**TO:** Brian Wilson, CVL Consultants of Colorado, Inc.  
**FROM:** Stacey Nerger, Associate Planner  
**DATE:** November 16, 2017  
**SUBJECT:** Trails at Crowfoot Filing No. 13 – Final Plat  
[Application SUB17-053]

**TRAILS AT CROWFOOT FILING NO. 13**

# TRAILS AT CROWFOOT SUBDIVISION FILING NO. 13

A PART OF THE SECTIONS 4, 8 AND 9, TOWNSHIP 7 SOUTH, RANGE 66 WEST OF THE 6th PRINCIPAL MERIDIAN,  
TOWN OF PARKER, COUNTY OF DOUGLAS, STATE OF COLORADO  
SHEET 2 OF 3

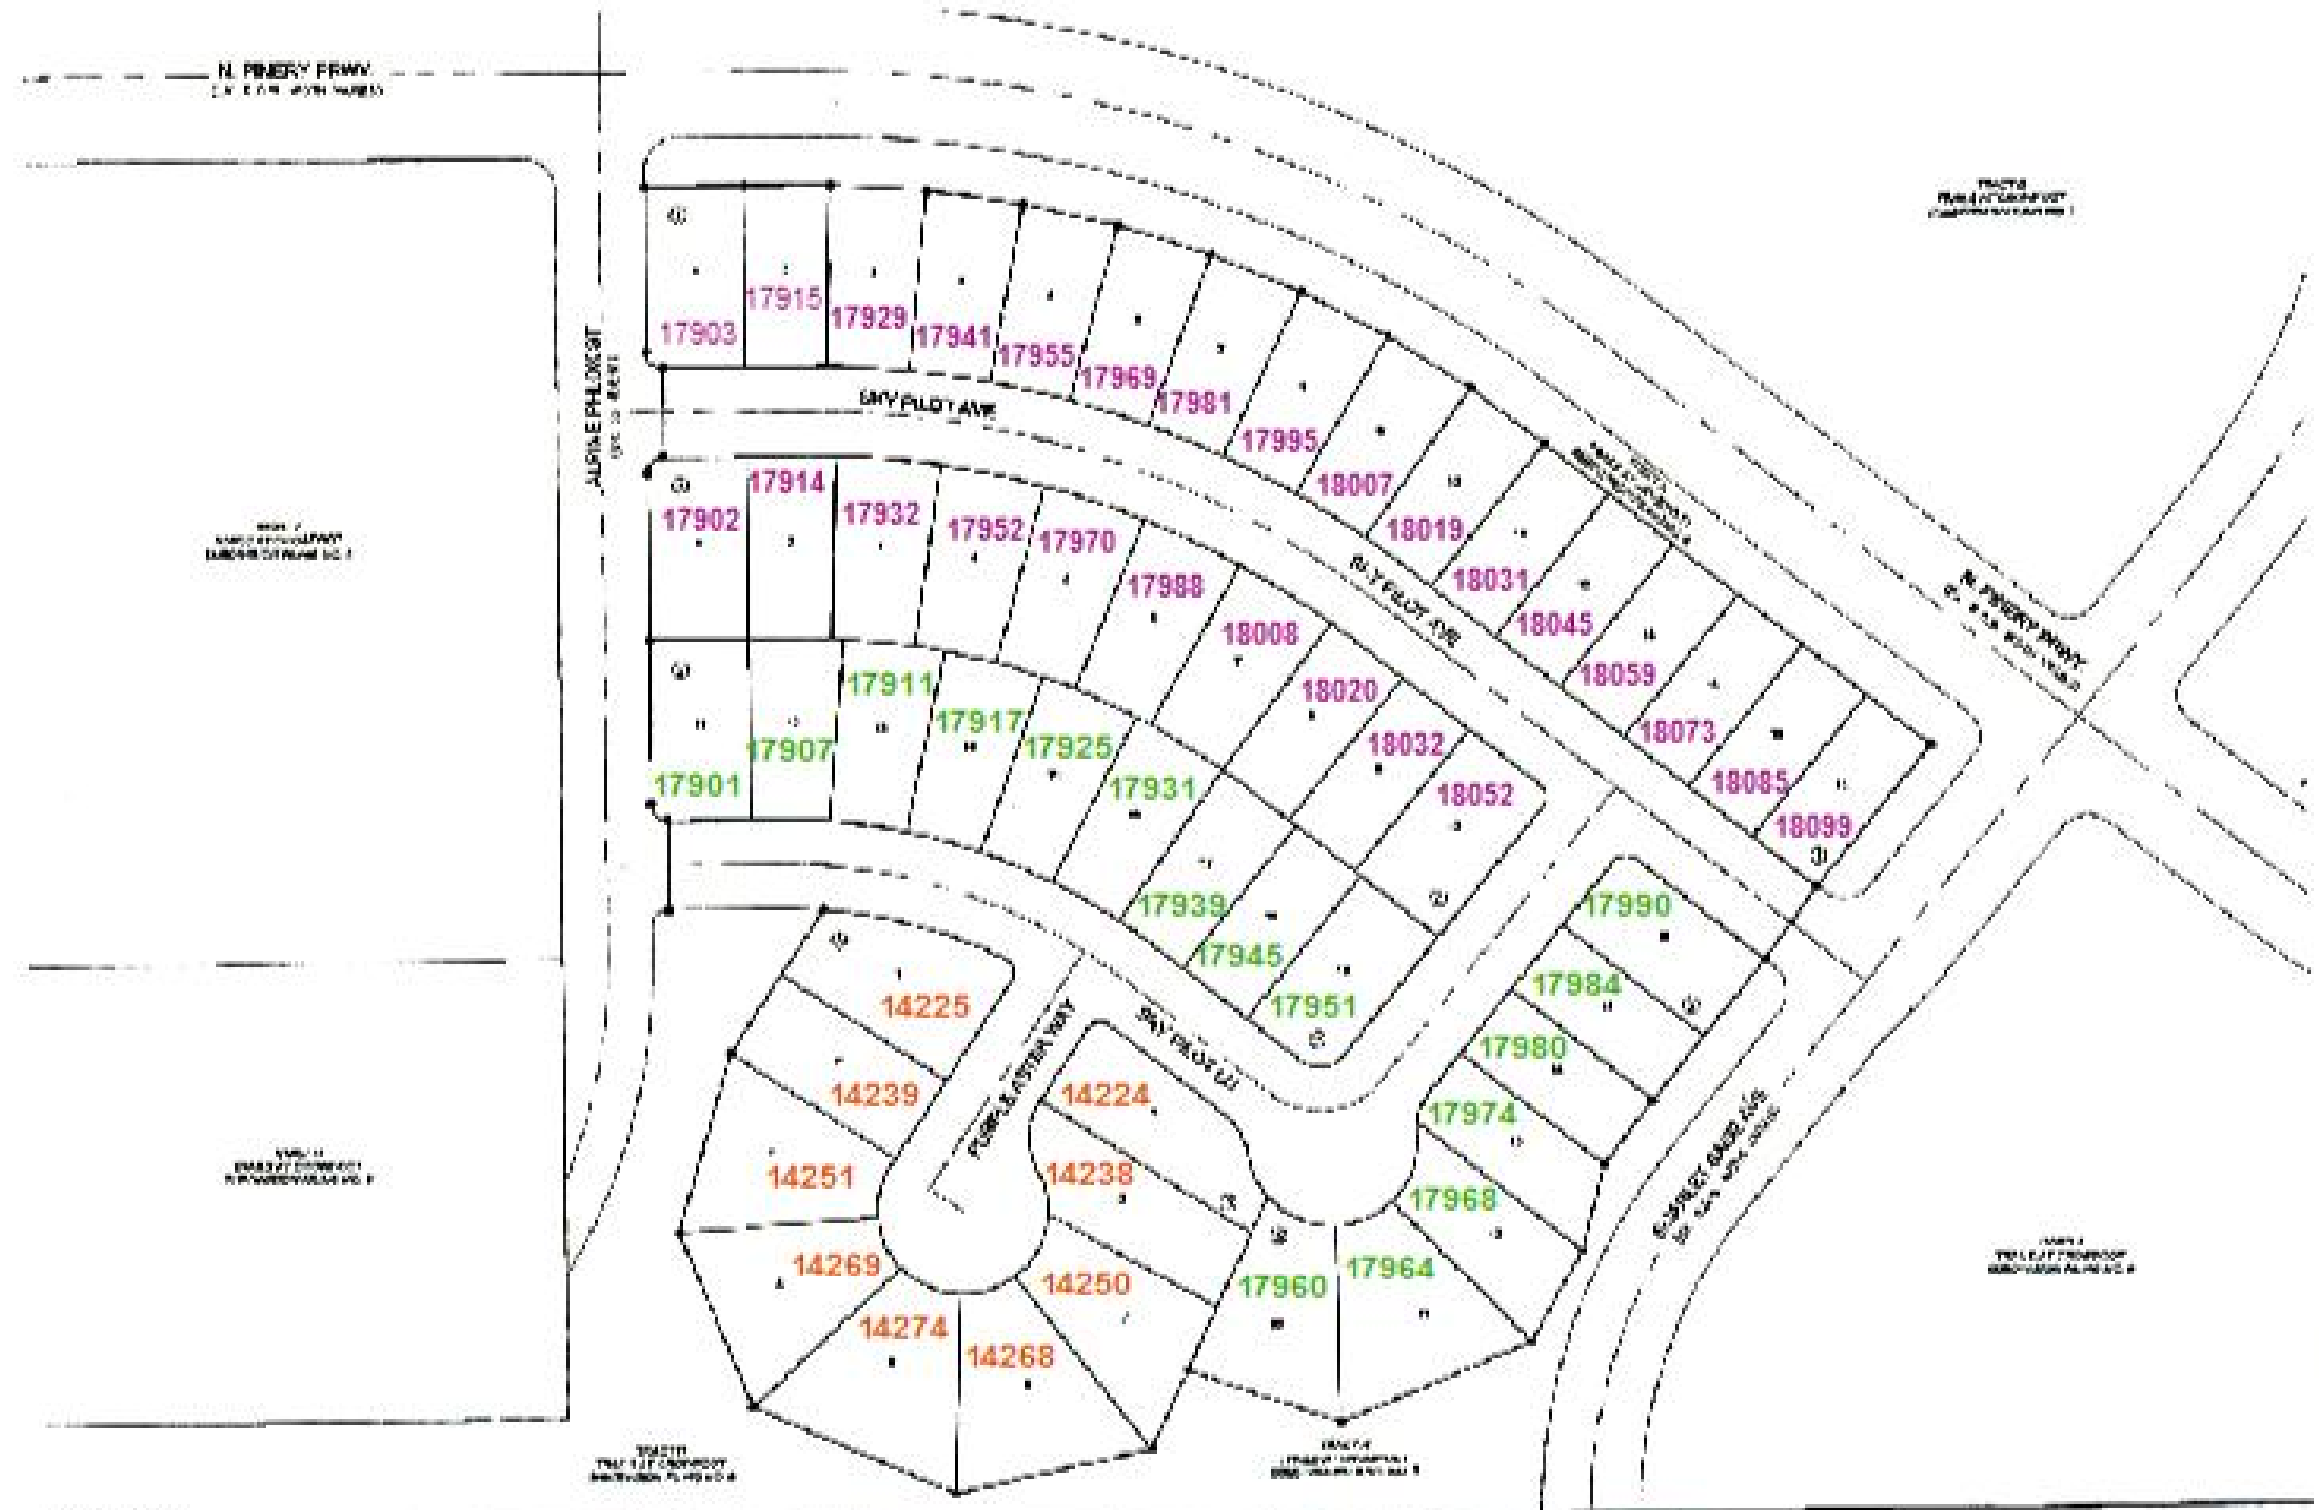
This should be 77.28%

Please also add square feet.

Please add a table showing the average, minimum and maximum lot size within this filing.
